**Subject** ▶ Change of Shifter Pin and Addition of Sleeve 4

**For Models** ▶ 6833, 6834

|                                      | ▶ Current              | ▶ New                  |
|--------------------------------------|------------------------|------------------------|
| Sectional view of the encircled area |                        |                        |

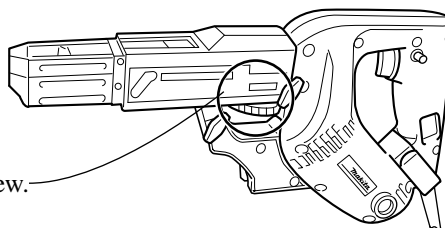
**Description** ▶ 1) For standardization, the current Shifter Pin has been replaced by the new Shifter Pin which has already been used for our new Model 6835DW.  
2) Because the length of new Shifter Pin is shorter than that of the current, one piece of Sleeve 4 has been added to fill the gap.

See the following sectional view.

|                                      | ▶ Current              | ▶ New                  |
|--------------------------------------|------------------------|------------------------|
| Shifter Pin                          | <br>(Part No.310061-5) | <br>(Part No.310091-6) |
| Sleeve 4                             |                        | <br>(Part No.257694-4) |
